NORTH FALLS

Offshore Wind Farm

Outline Construction Traffic Management Plan (Tracked)

Document Reference: 7.16
Volume: 7
Date: April~~March~~ 2025
Revision: 32

Drawing 104560-MMD-00-XX-DR-CE-1061_Rev01

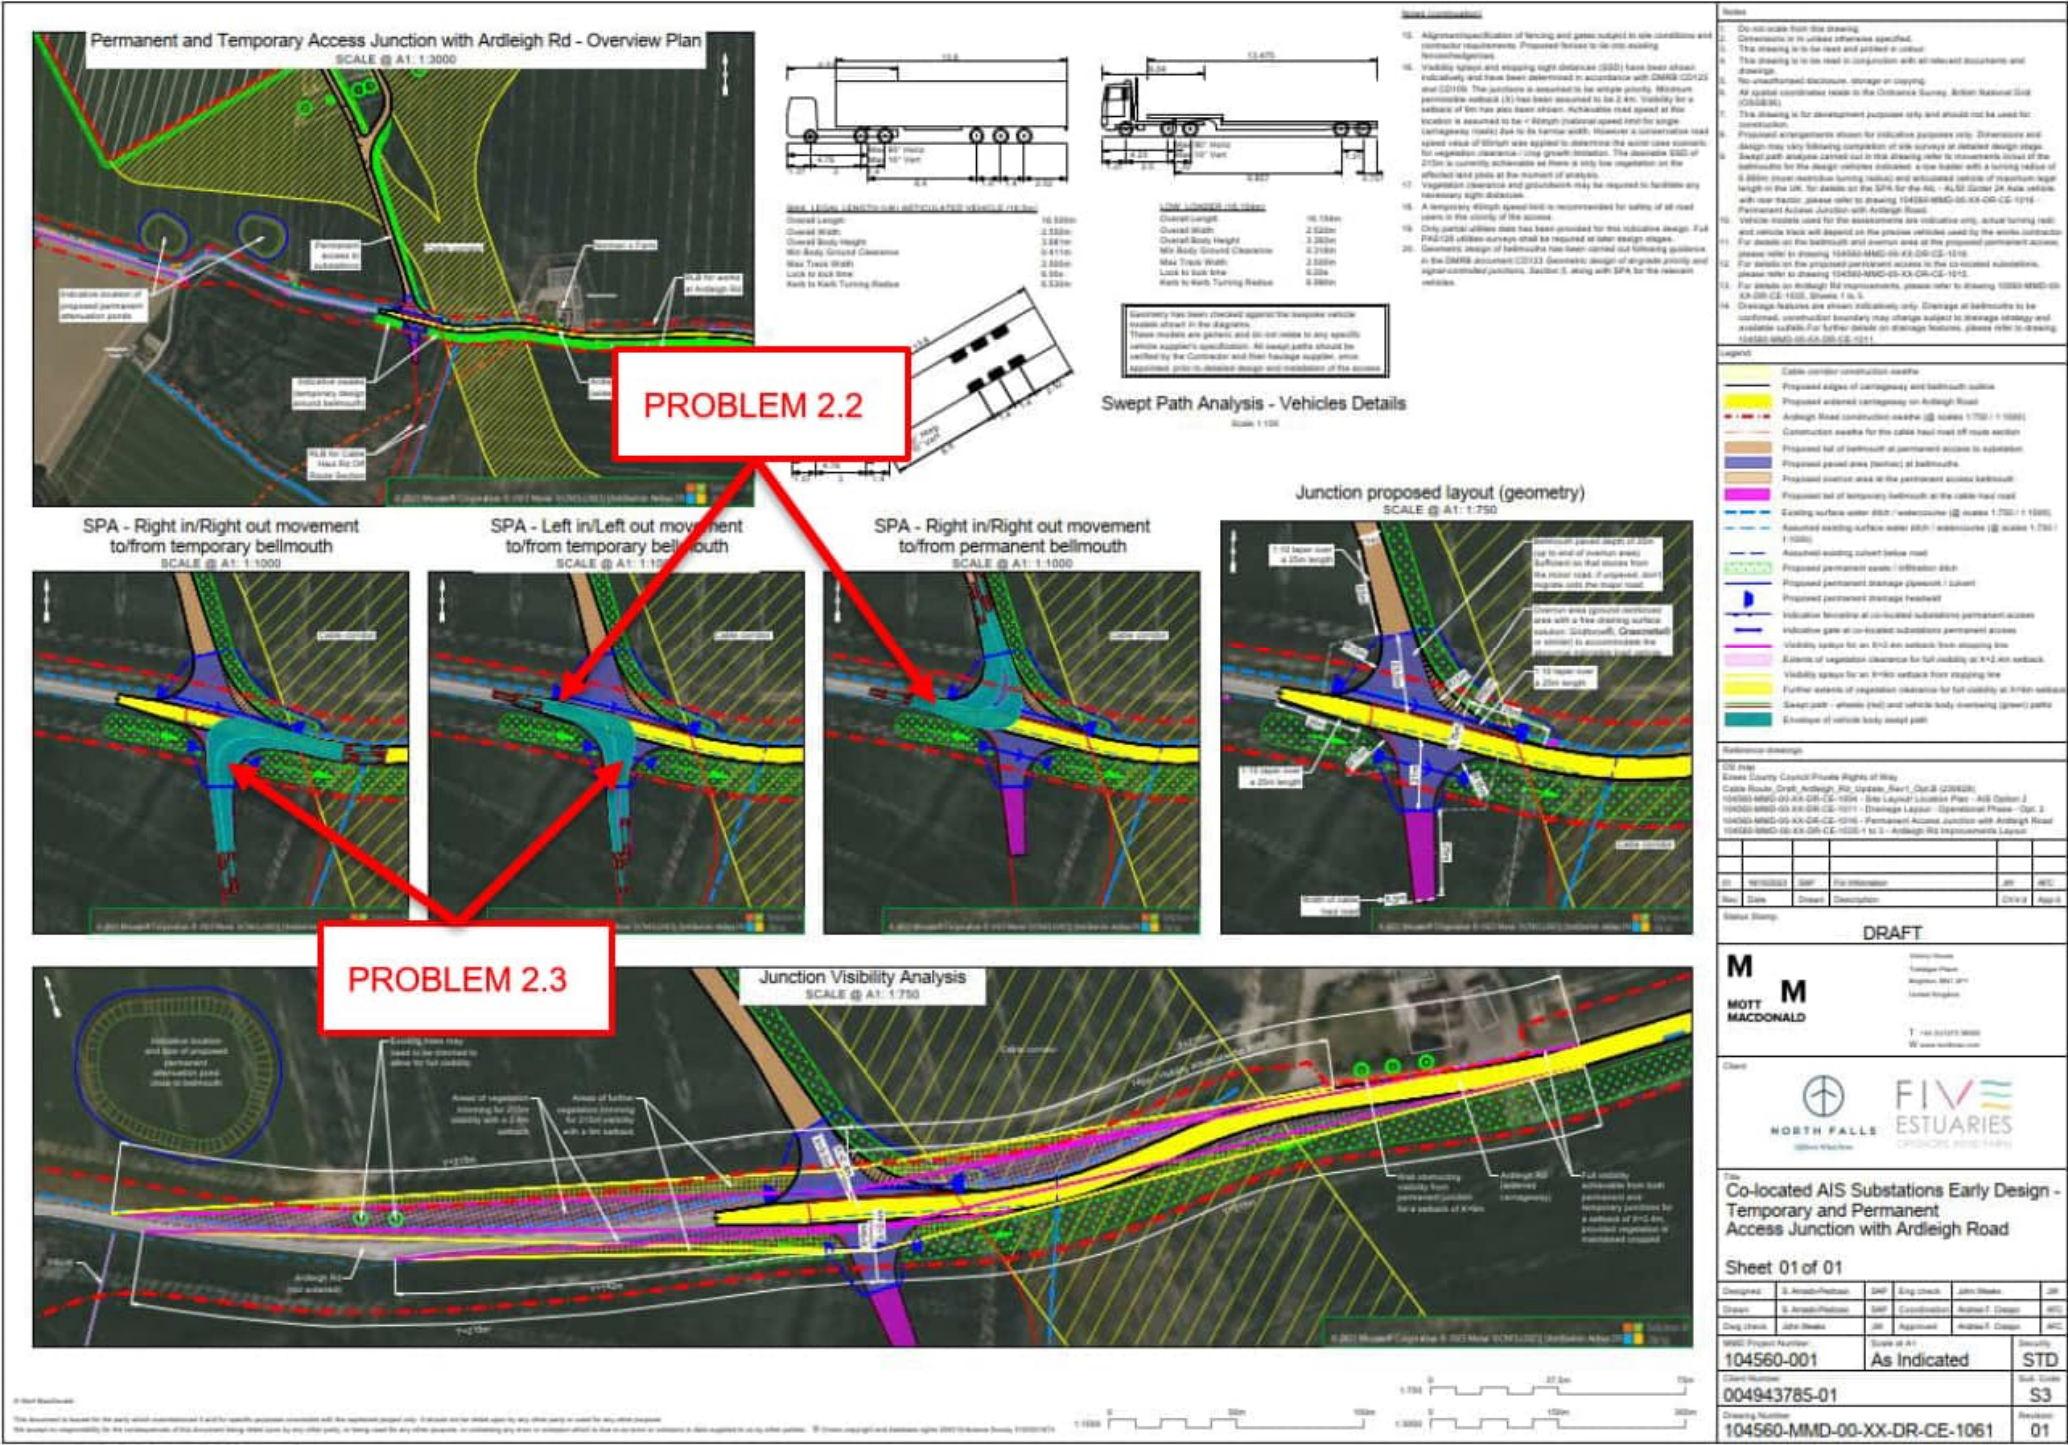
Drawing 104560-MMD-00-XX-DR-CE-1061_Rev01						
2.1	Location: Site Access (Temporary Access Junction with Ardleigh Rd) Summary: Overhead cables may lead to damage to infrastructure, vehicles and occupants. Onsite observations noted the presence of overhead cables that cross Ardleigh Road in various locations in the vicinity of the proposed development. The vertical alignment of proposed HGV access movements may lead to damage to infrastructure or damage to vehicles and injury to occupants.	It is recommended that the vertical assessment is carried out for the appropriate vehicle types to ensure no conflict remains.	● RSA problem and recommendation agreed. ● This matter will be appraised further as an integral part of the detailed design process, when full PAS128 utilities surveys are to be obtained, and drawings detailing diversion or undergrounding (and/or further measures required) of utilities in the vicinity of the proposed access junction and crossing will be developed to take due account of the safety problem and the aligned recommendation. ● A wider utility diversion / undergrounding assessment would need to be carried out by the third party in charge of the Ardleigh Rd improvement works design at the scheme detailed design stage, when full PAS128 utilities surveys shall be completed. Coordination between Mott MacDonald and that third party may be required. ● Notes 9 and 19 in drawing 104560-MMD-00-XX-DR-CE-1061_Rev01 are intended to account for this matter: ● Note 9. «Proposed arrangements shown for indicative purposes only. Dimensions and design may vary following completion of site surveys at detailed design stage». ● Note 19. «Only partial utilities data has been provided for this indicative design. Full PAS128 utilities surveys shall be required at later design stages».	TBC	TBC	This matter will be appraised further as an integral part of the detailed design process, when full PAS128 utilities surveys are to be obtained, and drawings detailing diversion or undergrounding of utilities in the vicinity of the proposed access junction and crossing will be developed to take due account of the safety problem and the aligned recommendation (TBC).

Drawing 104560-MMD-00-XX-DR-CE-1032-1_Rev02

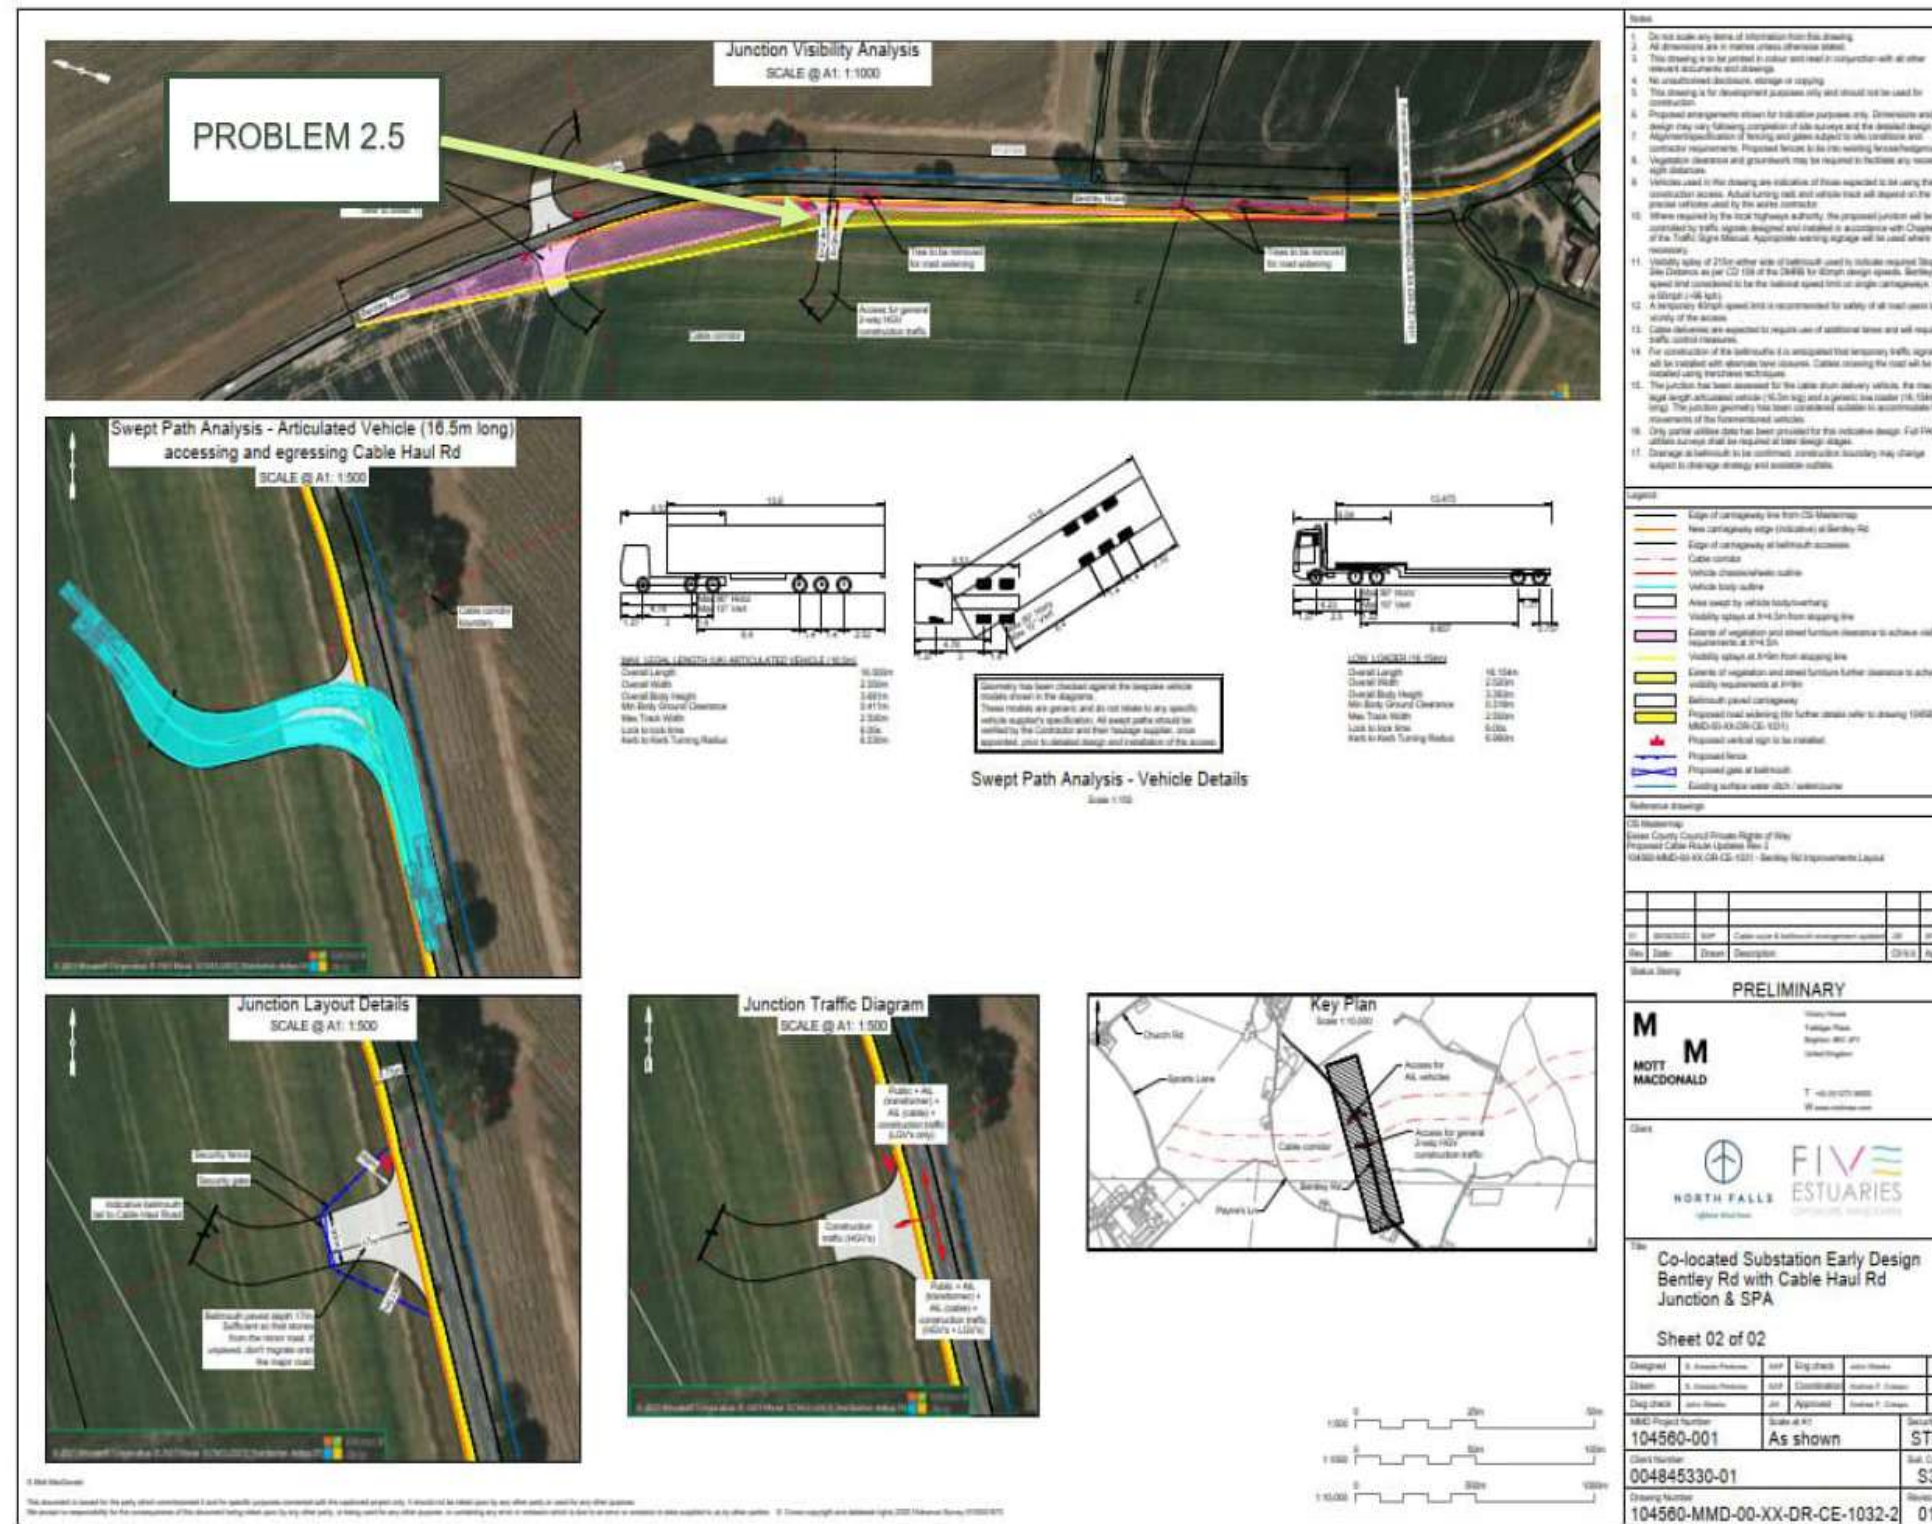
Drawing 104560-MMD-00-XX-DR-CE-1032-1_Rev02						
2.1	Location: Site Access (Temporary Access Junction with Bentley Rd). Refer to Appendix B. Summary: At a 9m setback, existing trees may obscure the visibility splay potentially leading to side swipe type collisions. Onsite observations noted that the presence of existing vegetation may constitute an obstruction to the junction visibility. Obstruction to visibility splays may lead to injudicious vehicle movements at the proposed junction leading to side swipe collisions between vehicles.	It is recommended that the trees be cut back and maintained as such that it does not pose an obstruction to the visibility splays.	● RSA problem and recommendation acknowledged but not agreed since it is not considered that these trees have an impact on the visibility clearance areas. The visibility splay with a 9m setback on the eastern side of Bentley Rd (northern side of Bentley Rd on drawing 104560-MMD-00-XX-DR-CE-1032-1) only captures a small area of road verge west of these existing trees, to run across the road to the other verge side west of Bentley Rd (South of Bentley Rd in drawing 104560-MMD-00-XX-DR-CE-1032-1). Cutting back or trimming the trees will not produce any changes to visibility. Trees are located on the southeast of the road and will cast shadow during most part of the day unless they are totally cut. ● In drawing 104560-MMD-00-XX-DR-CE-1031-3 for the same scheme (refer to Appendix C in this document), it is indicated the trimming of these existing trees to facilitate passage of vehicles, which will also help with general visibility. ● No designer action proposed.	TBC	TBC	No action (TBC).

Drawing 104560-MMD-00-XX-DR-CE-1032-2_Rev01						
2.5	Location: Proposed site access. Refer to Appendix B. Summary: The level difference between the carriageway and site could result in loss of control or side swipe type collisions. Onsite observations found that there was a difference in levels between the existing carriageway and the new access. An excessive gradient may create difficulty for large construction vehicles wishing to access Lodge Lane and may in turn lead to a lack of surface friction and slow egress movements potentially creating shunt / side swipe type collisions between egressing construction vehicles and vehicles travelling on Bentley Road.	It is recommended that the existing gradient be amended to an appropriate level for the restart movements of large vehicles accessing Bentley Road from the proposed site	- RSA problem and recommendation agreed. - This matter will be appraised further as an integral part of the detailed design process and drawings developed to take due account of the safety problem and the aligned recommendation.	TBC	TBC	This matter will be appraised further as an integral part of the detailed design process and drawings developed to take due account of the safety problem and the aligned recommendation. (TBC)

Ref.	RSA Problem	RSA Recommendation	Design Organisation Response	Audit Team Supplementary Comment	Client / Project Sponsor Comment	Agreed RSA action
			envelope, fits within the bellmouth outlines. The chassis envelope line will be brought forward in the drawing for clarity. - Also please note that vehicle models used to perform the SPA are conservative and representing a worst case scenario. We can conclude that if the vehicle chassis swept path fits within the carriageway limits with these conservative vehicle models (as it does), room is to be sufficient in reality. - Note 9 in drawing 104560-MMD-00-XX-DR-CE-1032-1_Rev02 («Vehicles used in this drawing are indicative of those expected to be using this construction access. Actual turning radii and vehicle track will depend on the precise vehicles used by the works contractor») and disclaimer shown in Vehicle Details («This model is generic and do not relate to any specific vehicle supplier's specification. All swept paths should be verified by the Contractor and their haulage supplier, once appointed, prior to detailed design and installation of the access») were included as caveats in relation to this matter.
